**ATTACHMENT 1**

**MARKED-UP TECHNICAL SPECIFICATIONS PAGES FOR CATAWBA**

**ATTACHMENT 3**

**DESCRIPTION OF PROPOSED CHANGES AND TECHNICAL JUSTIFICATION**

Figure 1: Alignment of  
Channel A During  
Normal Operation

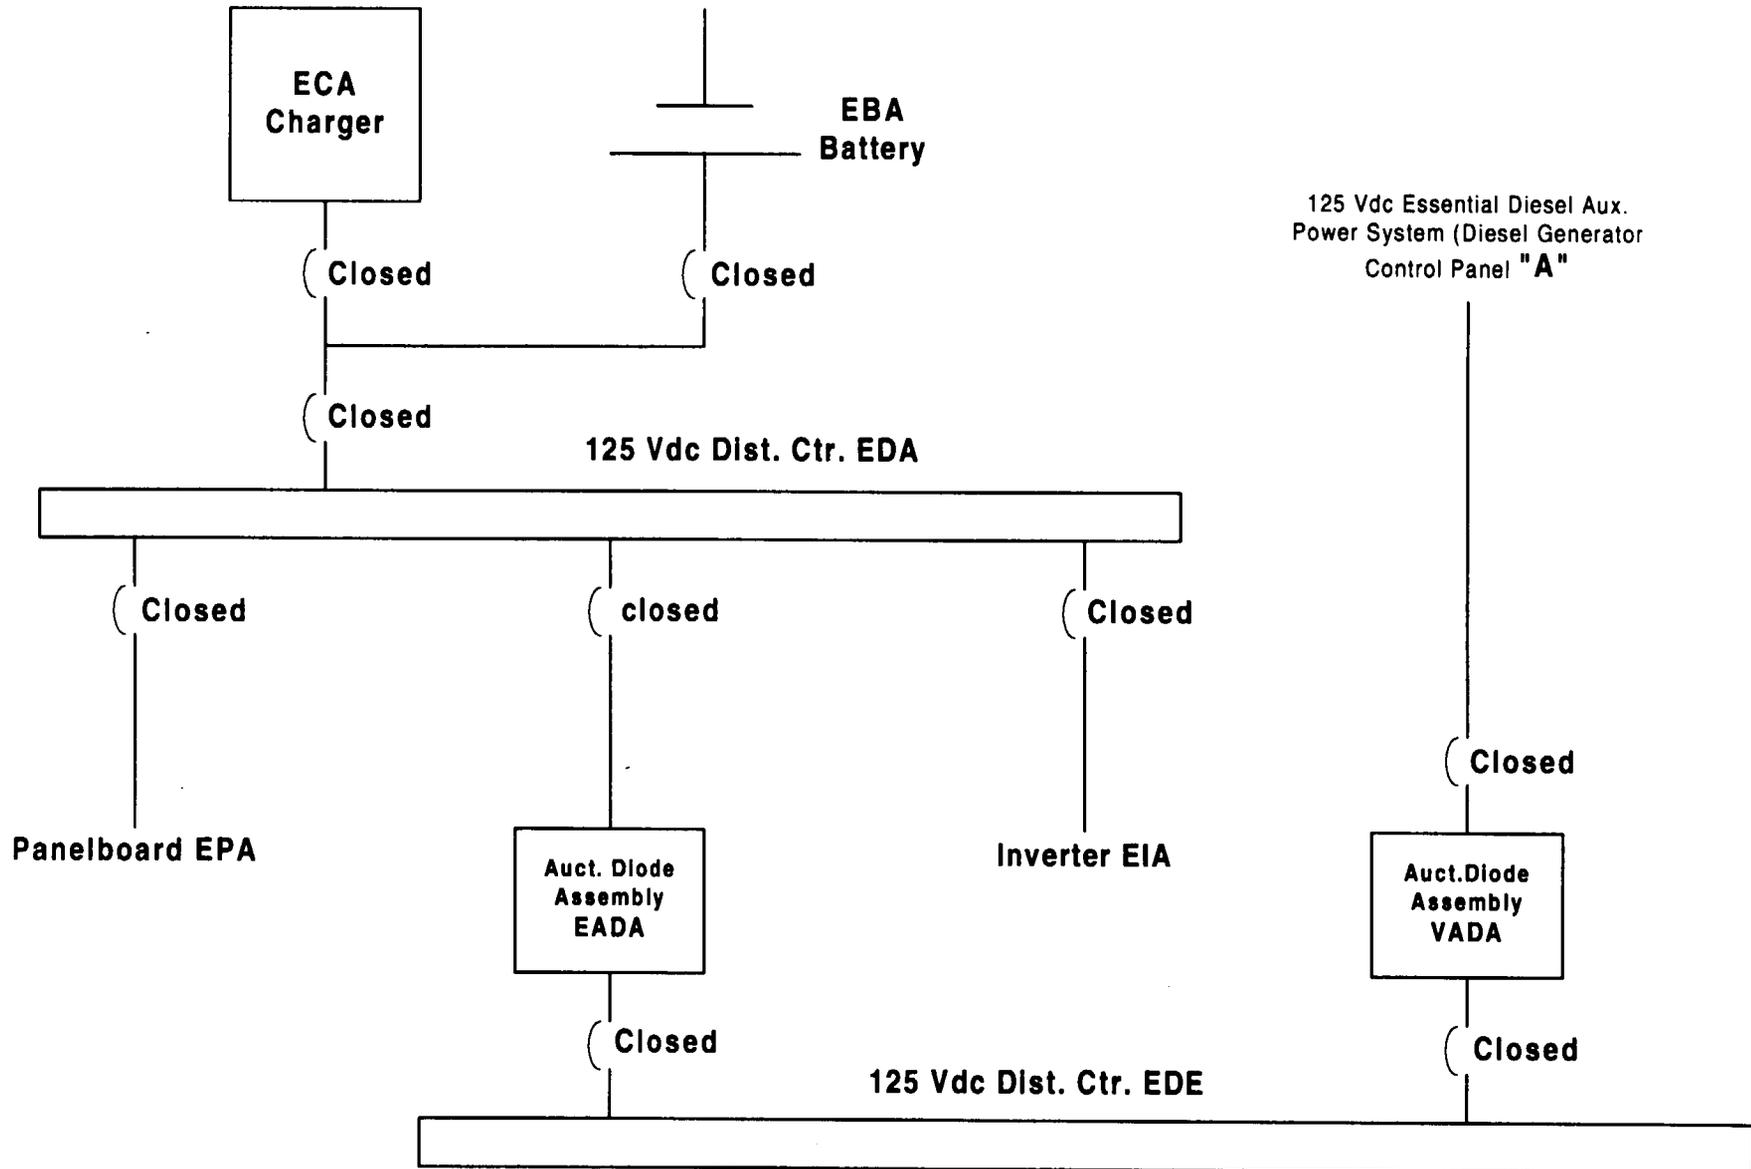
source. Refer to attached Figure 1 for a schematic representation of the normal system alignment for channel A, which is representative of all four channels, with the exception that channels B and C do not have the auctioneering diode assemblies' loads.

Figure 2: Alignment of Channels A & C During **EBA Out of Service**

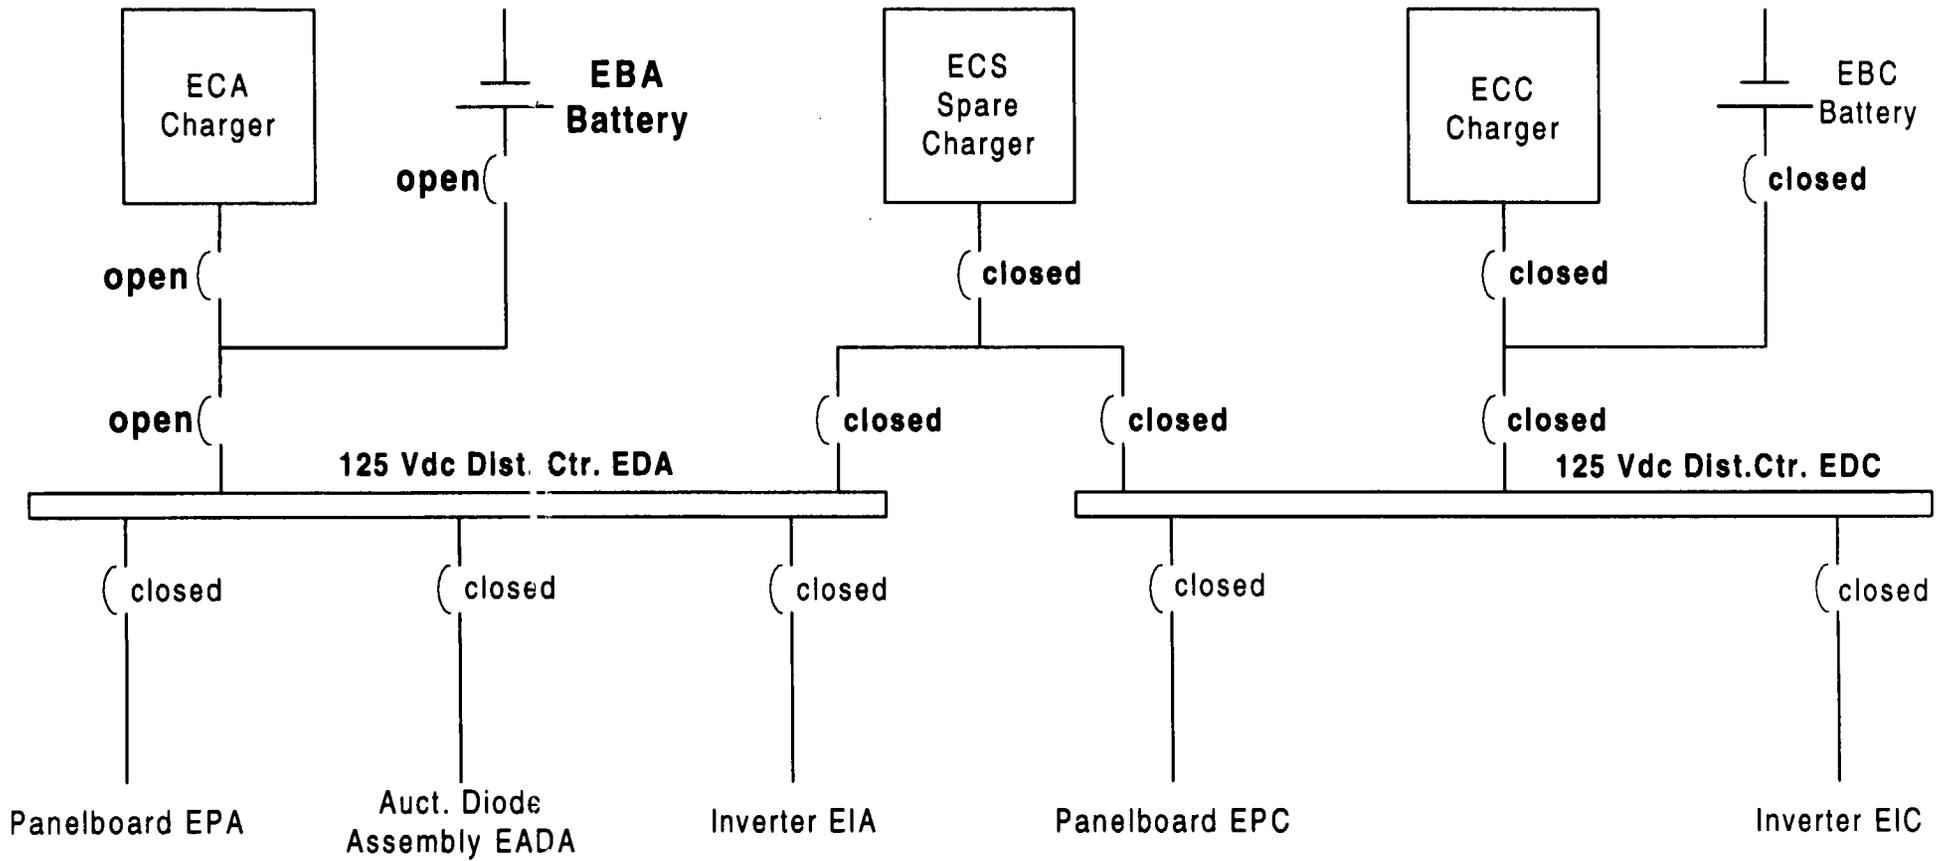
related load channel for two hours. For example, battery EBA is sized to simultaneously supply the design basis accident loads fed from distribution center EDA, auctioneering diode assembly EADA, and distribution center EDC. Refer to attached Figure 2.

Catawba proposes to conduct the battery service test and performance discharge test/modified performance discharge test with the unit on line by first declaring the battery and DC channel to be tested inoperable. The inoperable DC channel will then be tied to the other train-related DC channel using the above mentioned tie breakers. The required test will then be performed on the inoperable battery. Performance of the battery service test or the performance discharge test/modified performance discharge test can be accomplished in a short time period relative to the 10-day allowed outage time for an inoperable DC channel. It requires approximately 50 to 60 hours to conduct the battery service test or the performance discharge test/modified performance discharge test. This time includes recharging the battery and functional verification to ensure that the battery meets all TS requirements before it is returned to service. These test completion times are well within the 10-day allowed outage time for an inoperable DC channel. During the performance of the required tests, both safety trains will continue to remain operable.

As an example, if a test is being conducted on battery EBA, channel A would first be declared inoperable. Channel A would then be tied to battery-backed channel C. Channels B and D would be unaffected during the conduct of the test. Therefore, both safety trains would still be capable of performing their required functions during an accident, since each battery has the ability to supply two load channels for a two-hour period during a design basis accident. Figure 2 illustrates the alignment of channels A and C during battery EBA testing.
